DOCUMENT 009113 - ADDENDA

- A. Addendum No. Two.

- A. Project Name: Skatium Locker Room Renovation.
- B. Owner: Township of Haverford.
- C. Owner's Representative: C.B. Development Services, Inc.
- D. Architect: BKP Architects.
- E. Date of Addendum: October 4, 2024

Skatium Locker Room Renovation
Responses to Bidder Questions and Written Identification of Modifications to Project Documents

1/2"=1'-0"

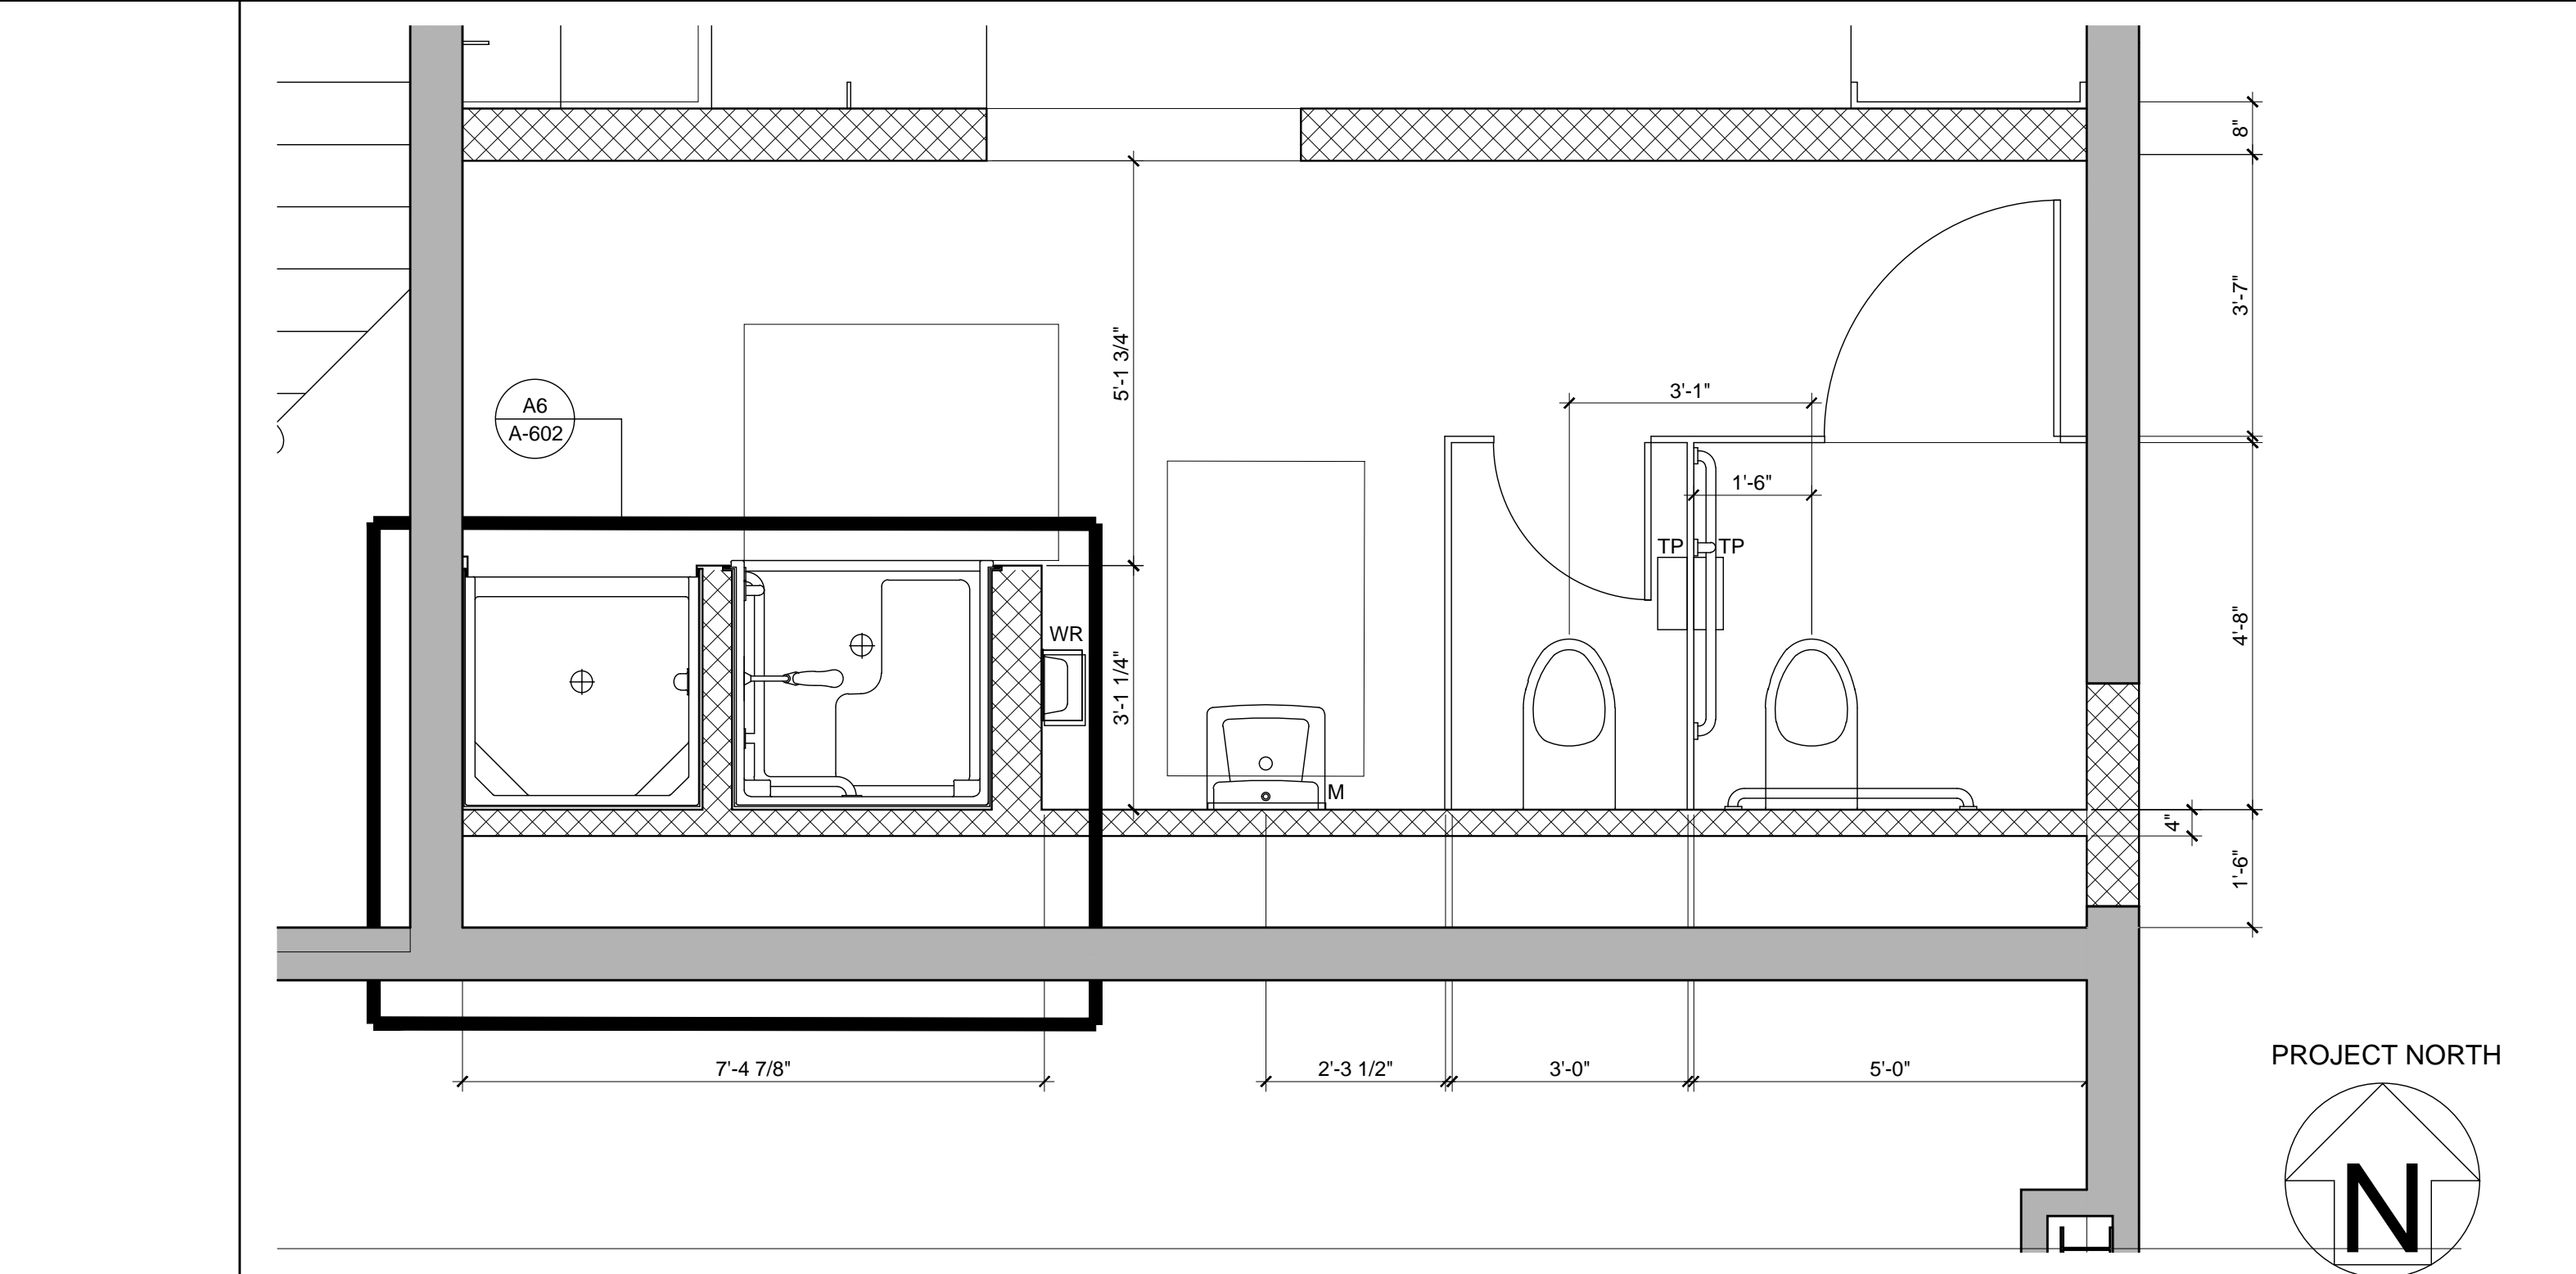
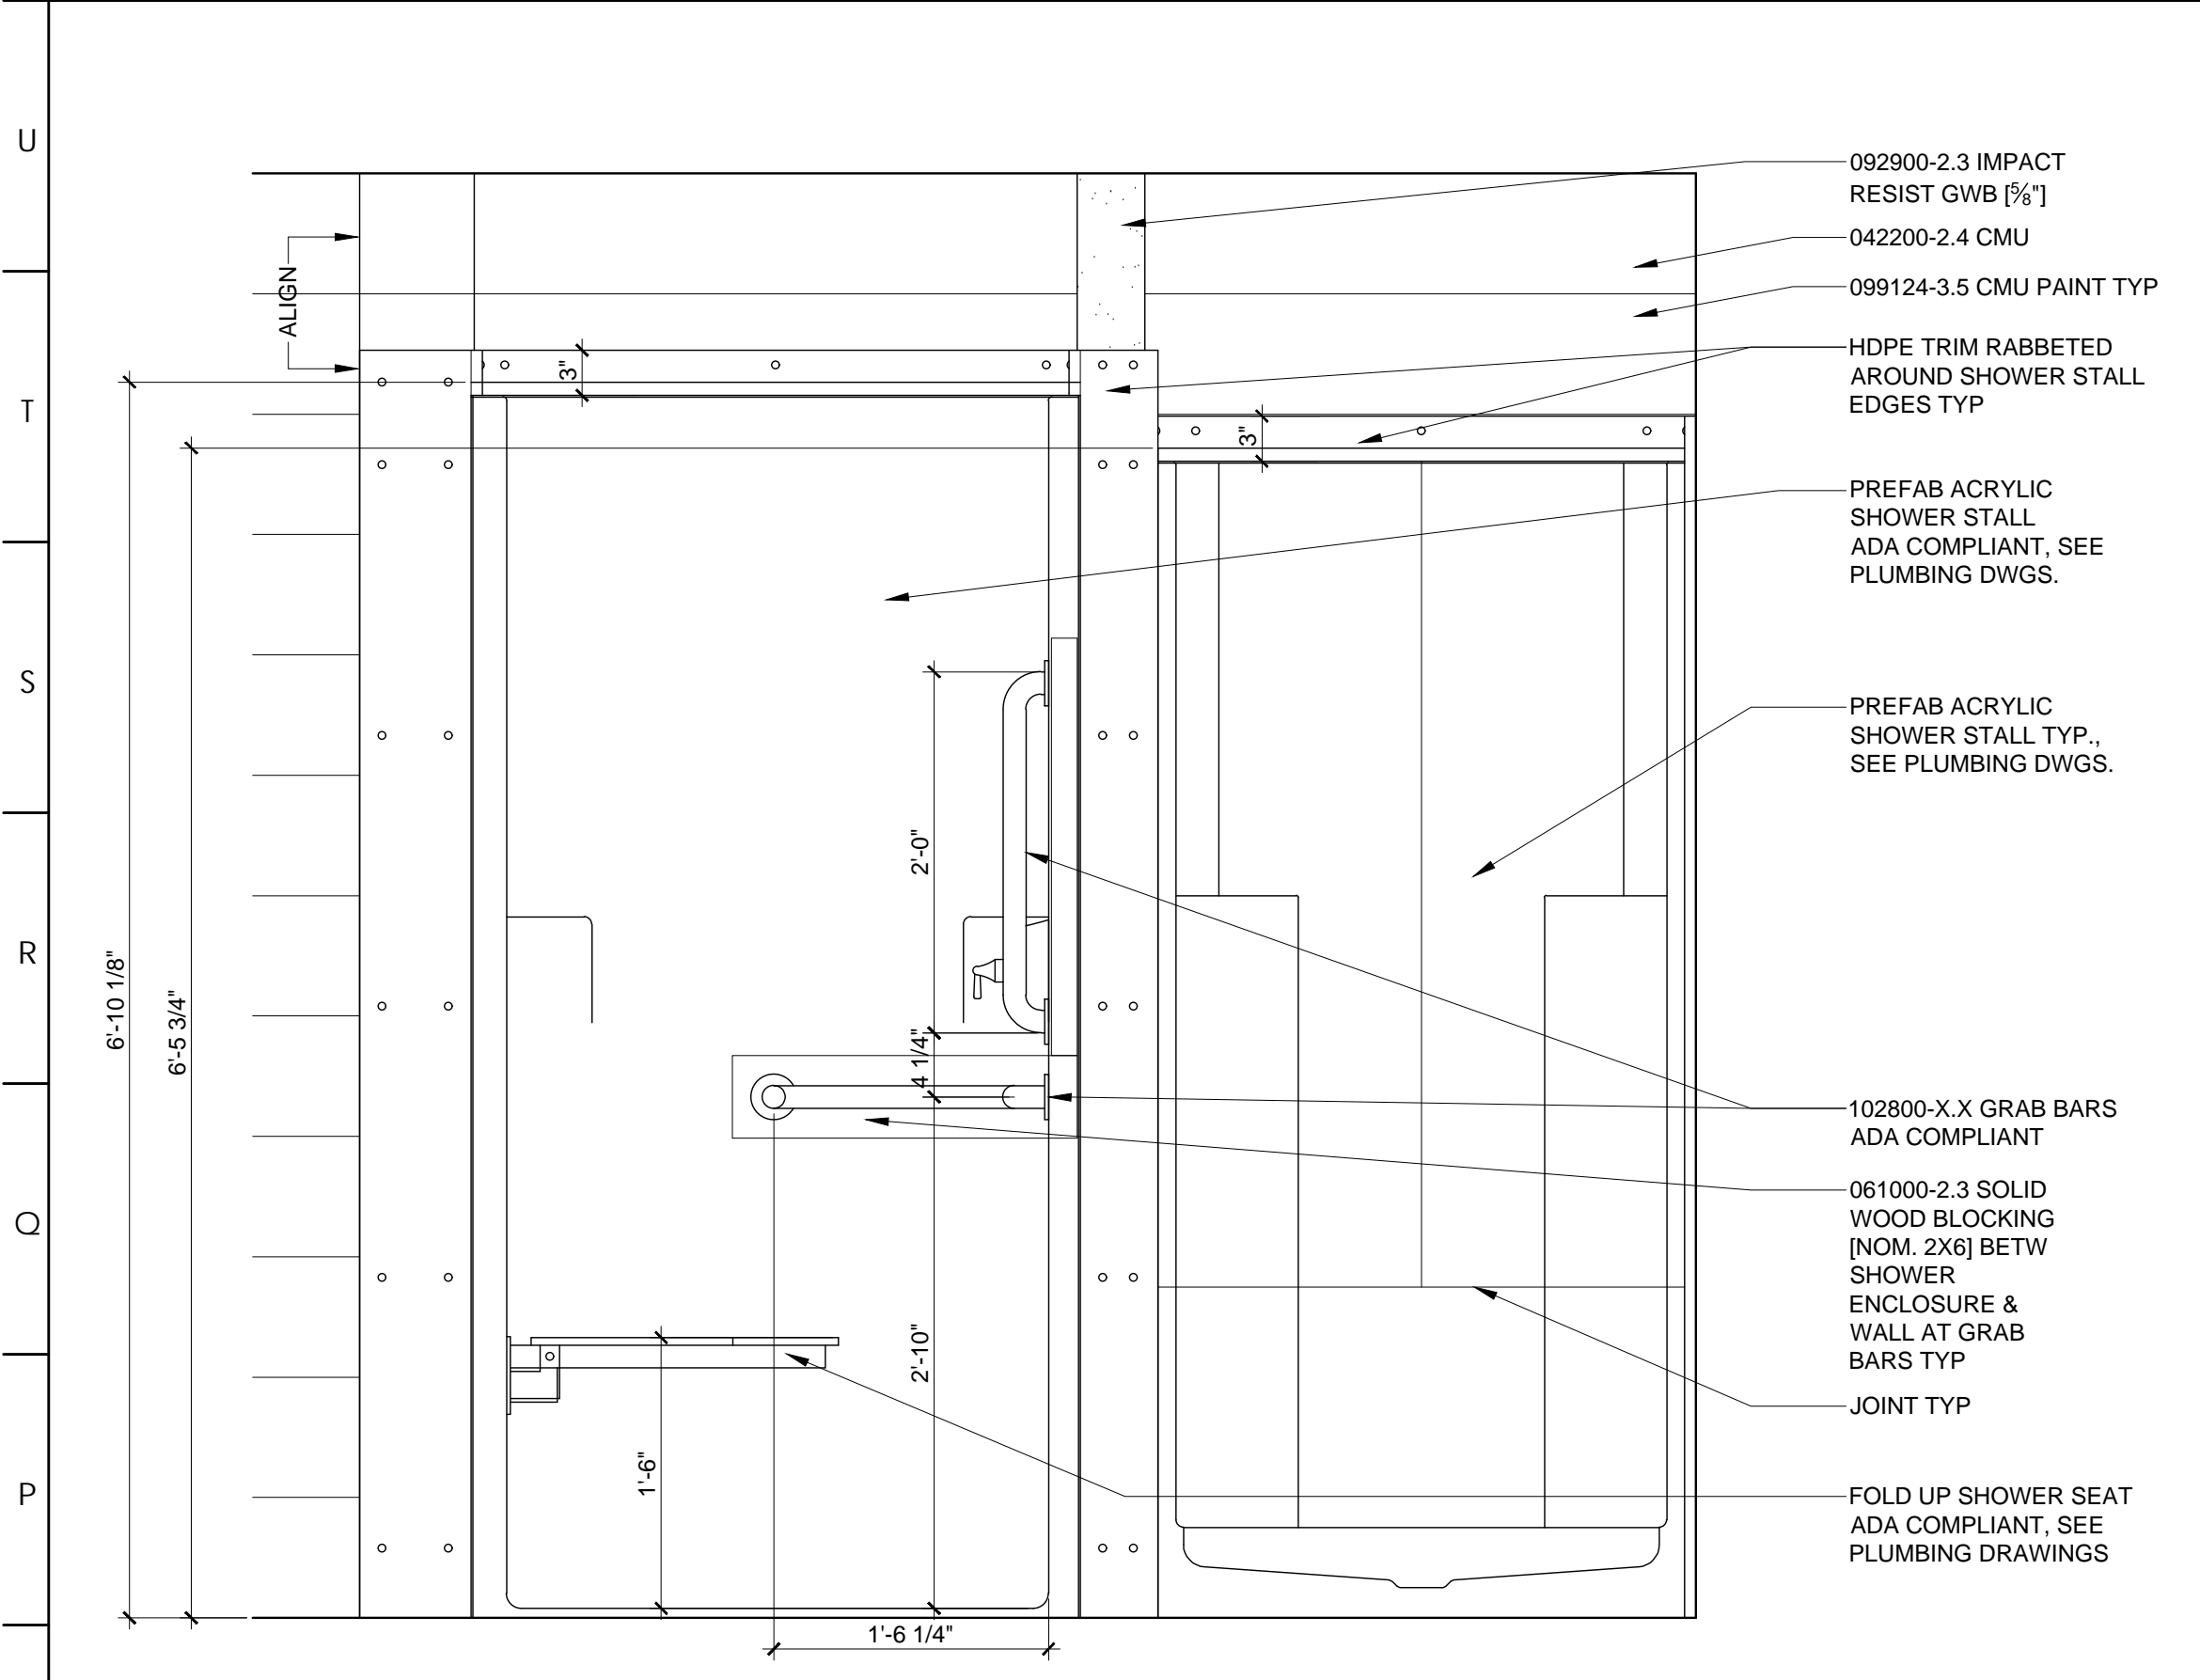
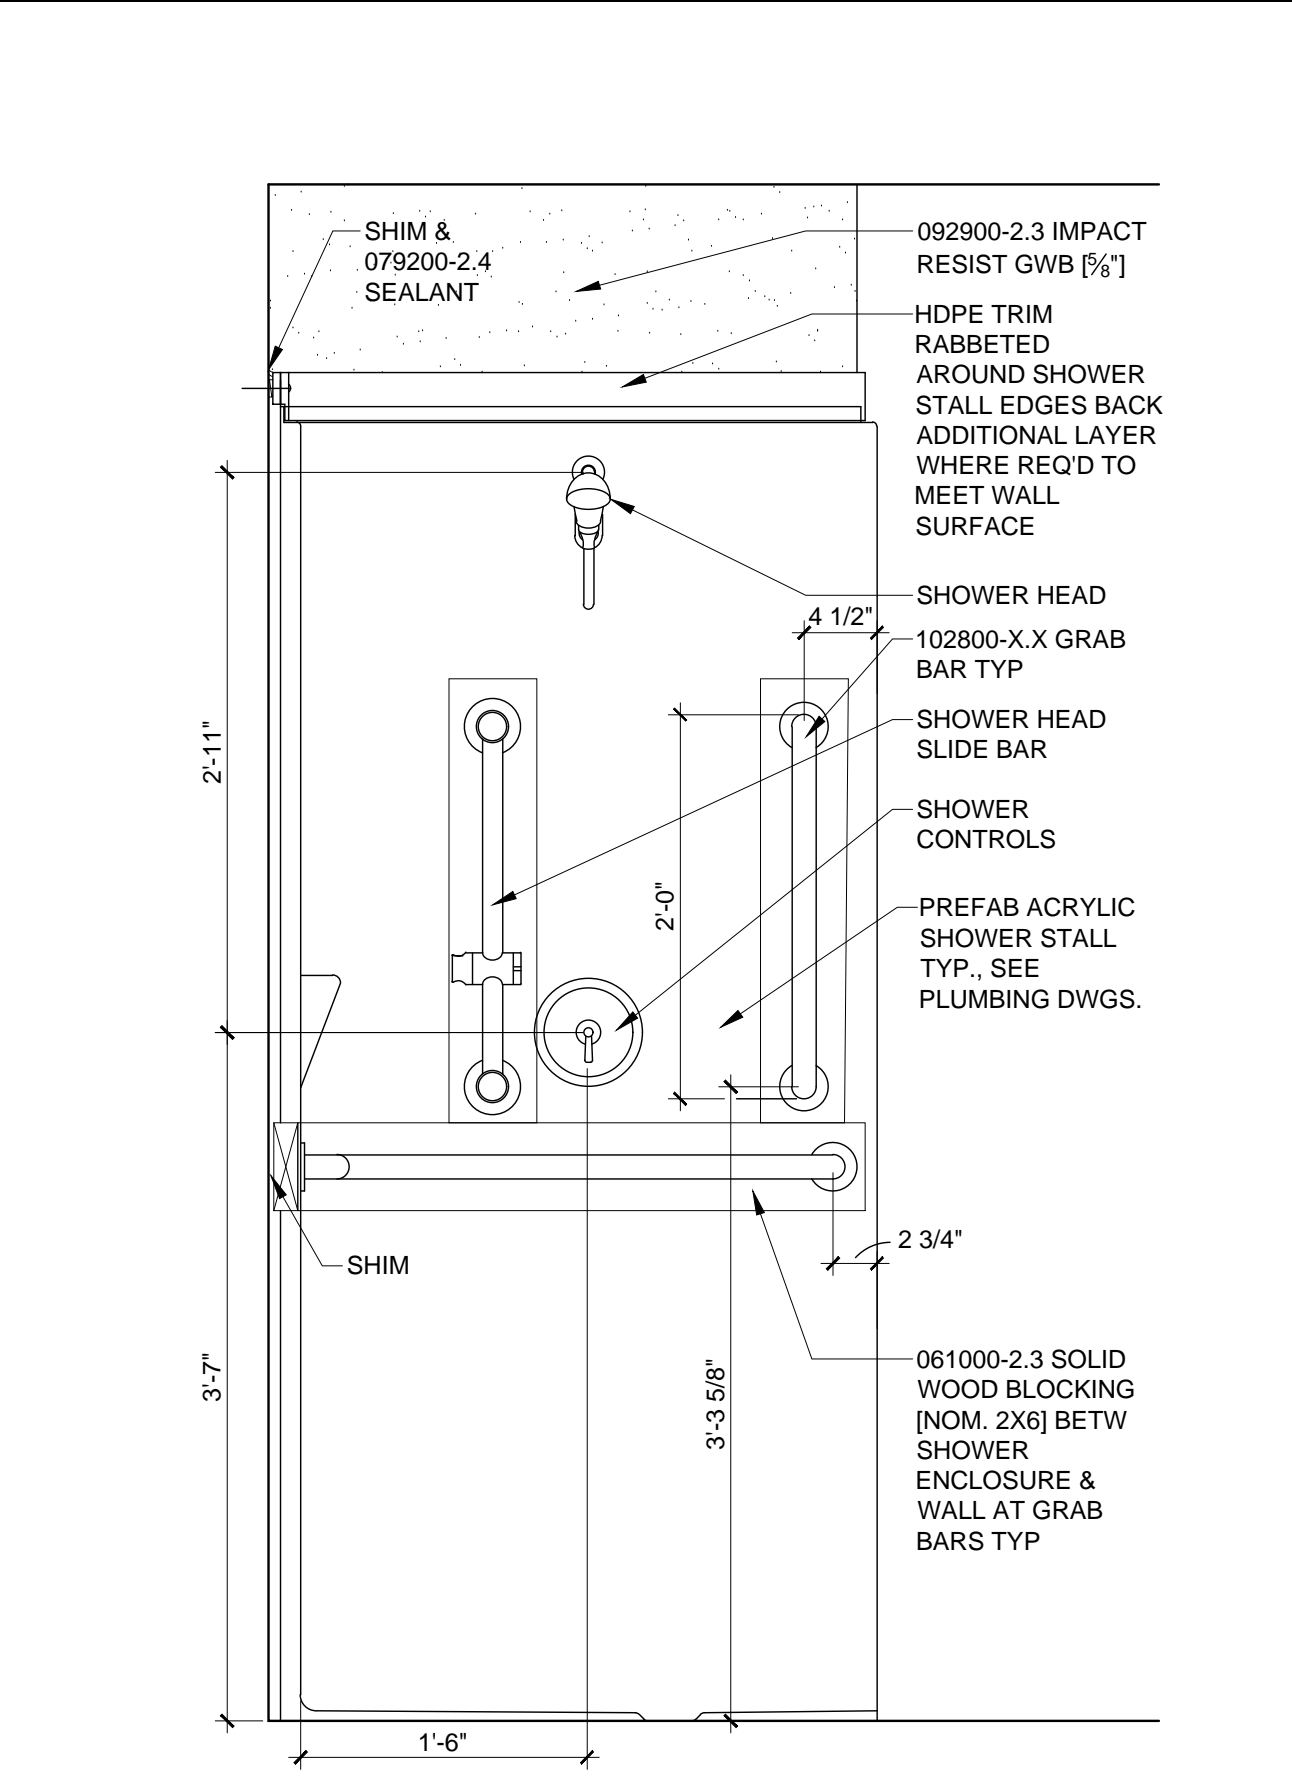
8. Several sheets reference Sheet A-100 which does not exist. Please advise.

- K. Drawing A-602 has been modified, removing references to Sheet A-100, replaced with reference to Sheet A-701.

Reference to Sheet A-100 should have been A-701. Drawing sheets A-601 and A-602, which are affected by this change have been revised and issued with Addendum #2.
